# **SUNNYVALE EAST AND WEST CHANNELS FLOOD PROTECTION PROJECT**

## **Third Addendum to the Final Environmental Impact Report**

**September 2025**

Figure 1: Joint Wall Alignment

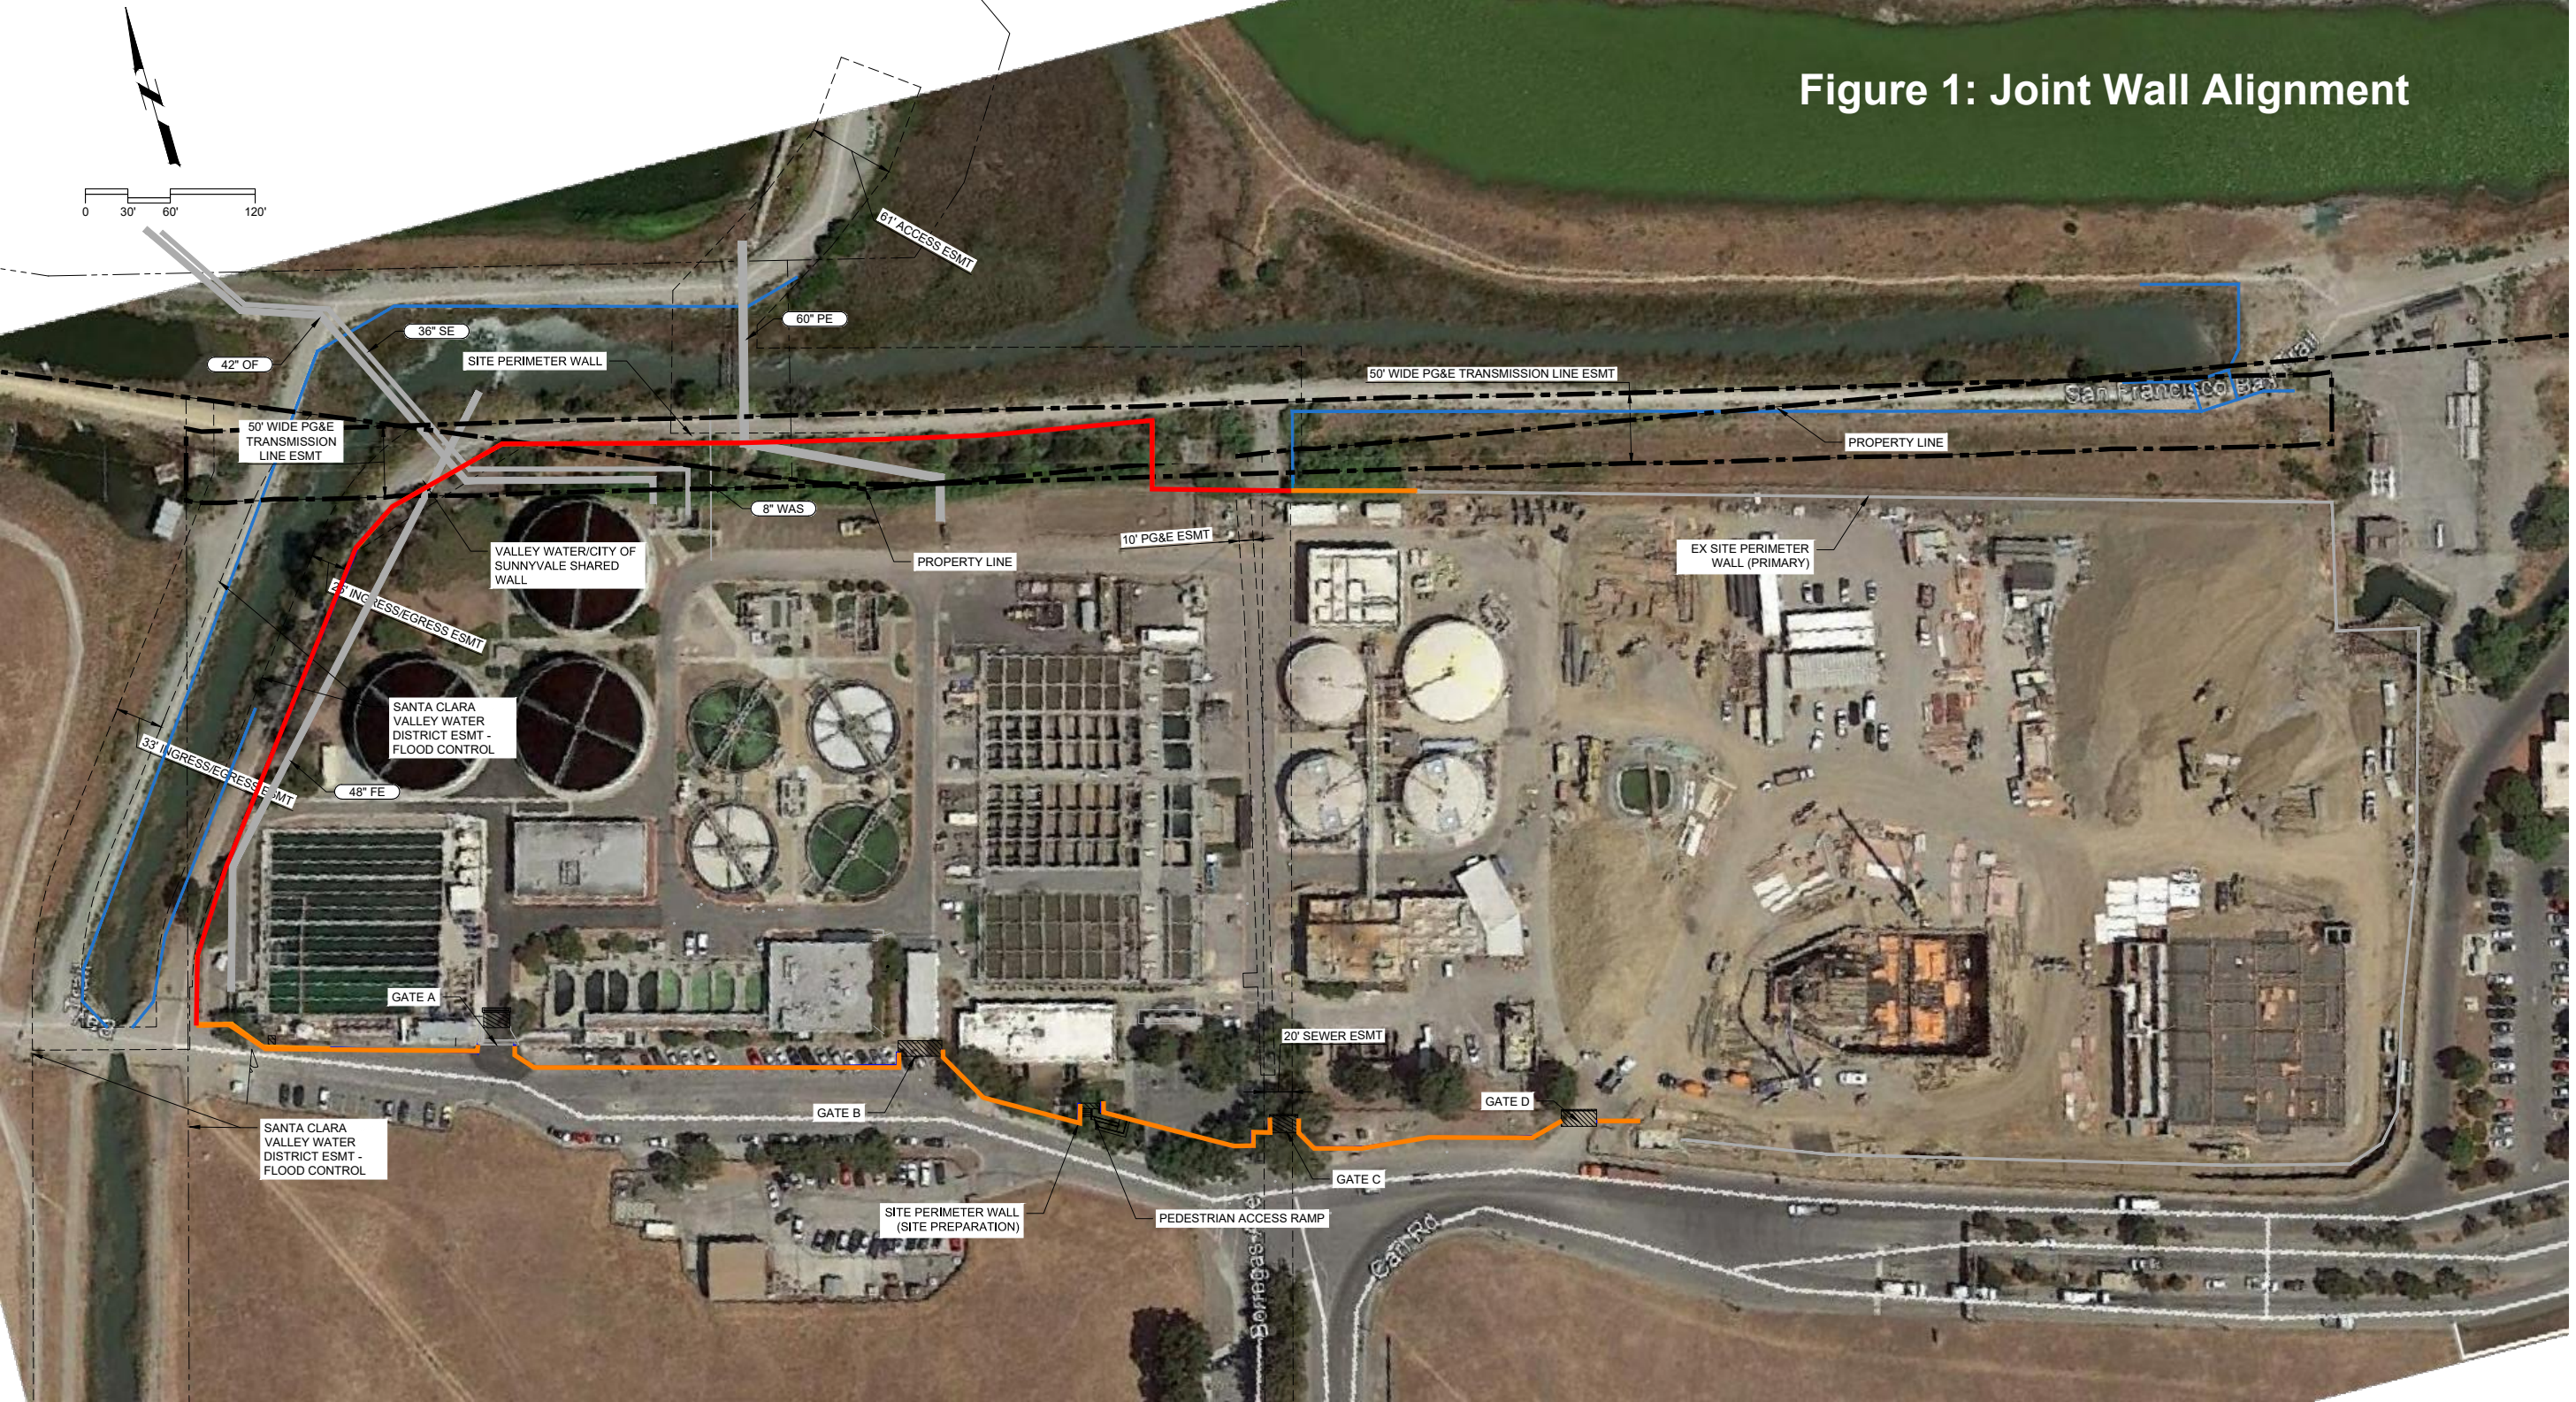
Recognizing the mutual need for a wall at this location, the City and Valley Water have developed plans for the Joint Wall, which combines segments of the WPCP perimeter wall and original Valley Water floodwall adjacent to the Sunnyvale West Channel. The Joint Wall would be approximately 1,100 feet in length and would extend from the Carl Road bridge to the northeastern edge of the WPCP (**Figure 1**). The Joint Wall would follow the same alignment as the originally proposed floodwall, except at its northeastern end, where it would include two 90 degree bends to tie into a separate portion of the proposed WPCP security wall. The overall construction footprint of the Joint Wall is substantially similar to the construction footprint associated with the originally proposed floodwalls. As such, construction of the Joint Wall would involve similar vegetation pruning where necessary around the perimeter of the WPCP and a temporary closure and detour of the Bay Trail segment adjacent to the WPCP perimeter similar to the original proposed Project.

The Joint Wall has been designed consistent with Valley Water's original floodwall design elevation of 17 feet North American Vertical Datum of 1988 (NAVD88). This elevation is based on Valley Water design criteria to provide 100-year flood protection with accommodation of up to 2.6 feet of sea level rise. Additionally, the Joint Wall would be approximately 8 feet above the existing grade and include three strands of barbed wire, consistent with City design criteria for a security wall. Construction of the Joint Wall would be conducted by the City in a manner consistent with the floodwall construction methods described in the Project EIR, including maximum excavation depth with the range provided in the Project EIR (3.5 to 18.5 feet) and use of an anchor drilled pier foundation. In addition to the 1,100 feet section of Joint Wall, Valley Water would construct a transitional section of floodwall as part of the Project to connect from the northern terminus of the Joint Wall to the Valley Water proposed floodwall along the existing levee near the downstream end of the Sunnyvale West Channel. No other modifications to floodwalls or other components of the Project are proposed.
